# SITE DEVELOPMENT PLANS FOR MAIN EVENT ENTERTAINMENT

## CIVIC CENTER BOULEVARD WEST CHESTER, OHIO

0		WEST CHESTER SUBMITTAL #1	05/20/15 WAB
▲		ADDENDUM #1	07/22/15 WAB
COVER		C 2015	
COVER		STATE OF OHIO WILLIAM A. BUTZ, JR. E-79758 PROFESSIONAL ENGINEER REGISTERED BY	
MAIN EVENT WEST CHESTER		600 EAST 96TH STREET, SUITE 460 INDIANAPOLIS, INDIANA 46240 PHONE: 317-218-9560 WWW.KIMLEY-HORN.COM	
MAIN EVENT WEST CHESTER		SHEET NUMBER C0.0	
RECEIVED AUG 13 2015 BY:			
MAIN EVENT WEST CHESTER		MAIN EVENT ENTERTAINMENT CIVIC CENTER BLVD., WEST CHESTER, OH	
MAIN EVENT WEST CHESTER		6652 PINECREST DR., SUITE 100, PLANO, TX 75024

GRADING PLAN

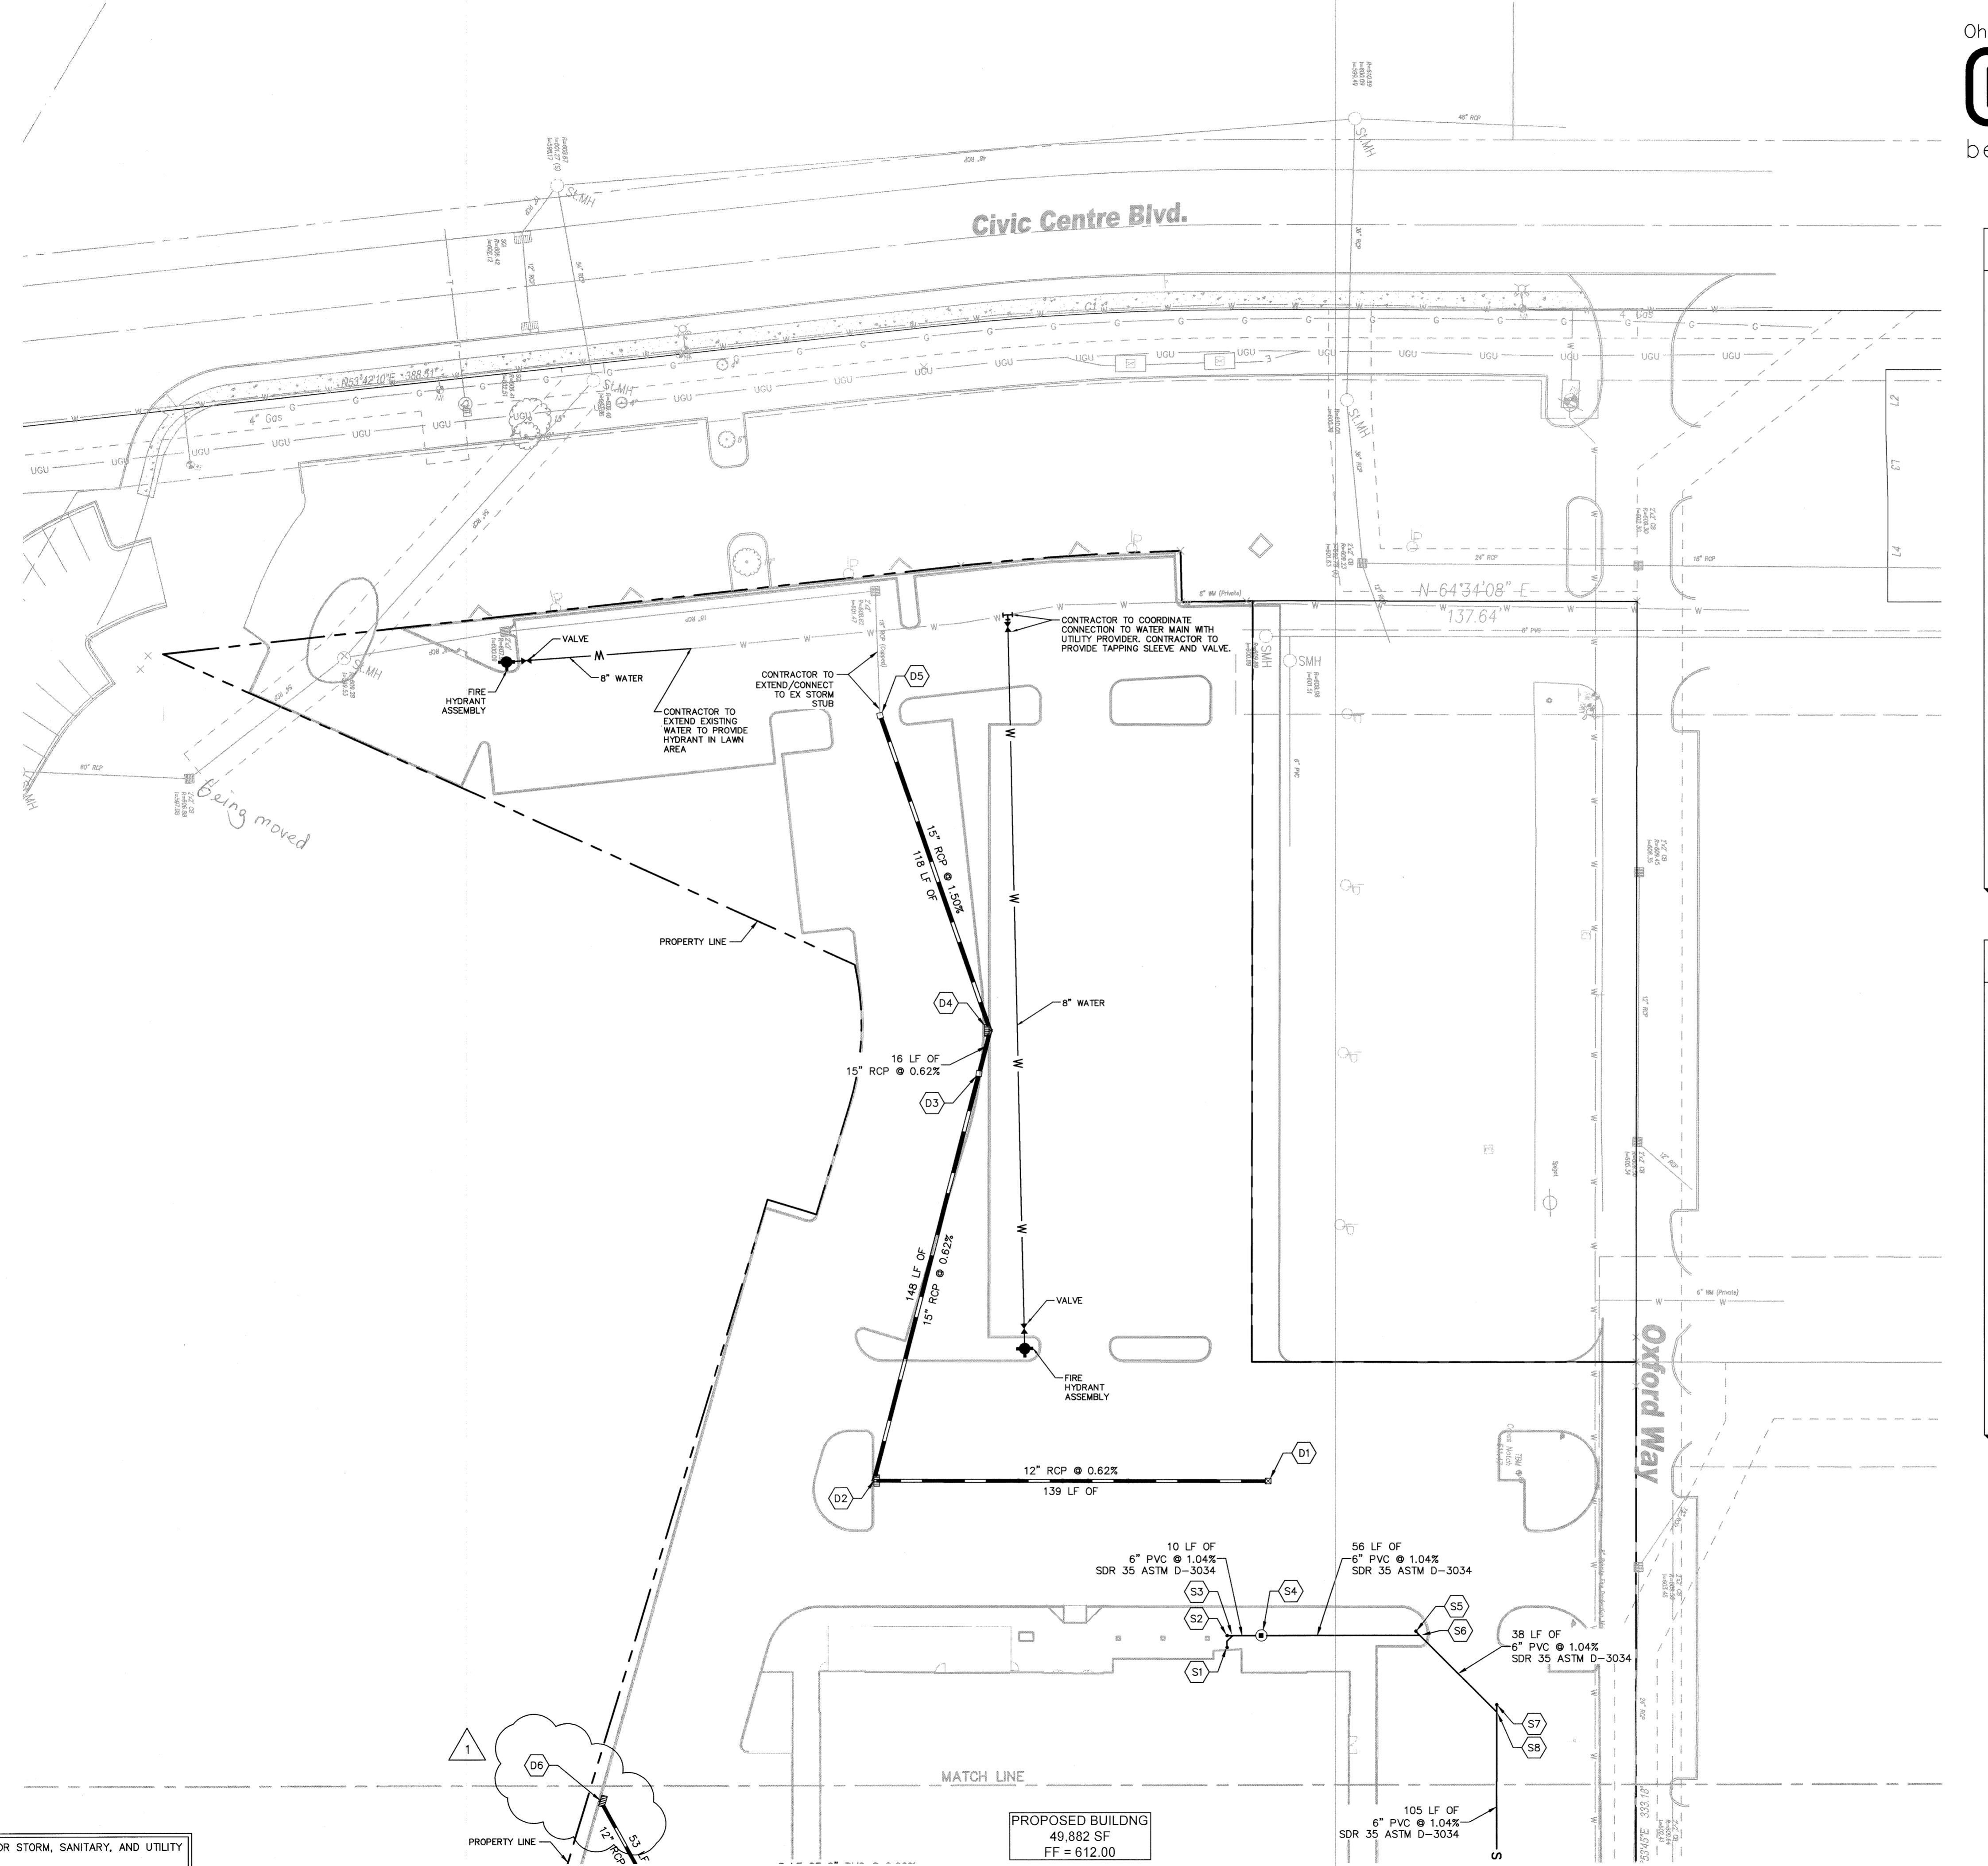
ELEVATION NOTE:  
TE THAT WITH ADDENDUM #1, THE EXISTING SURVEY AND PROPOSED GRADING  
S BEEN MODIFIED TO REFLECT A DATUM CHANGE. THE DATUM CHANGE  
NERALLY CHANGED THE EXISTING TOPOGRAPHY BY 0.62-FEET. WITH THIS  
ANGE, THE PROPOSED GRADING WAS ALSO MODIFIED AND AT THE LOCATIONS  
ERE THE SITE TIES TO EXISTING AND FUTURE DEVELOPMENT, GRADES WERE  
JUSTED ACCORDINGLY. CONTRACTOR TO REPORT ANY DISCREPANCIES IN GRADE  
THE ENGINEER AND OWNER PRIOR TO CONSTRUCTION.
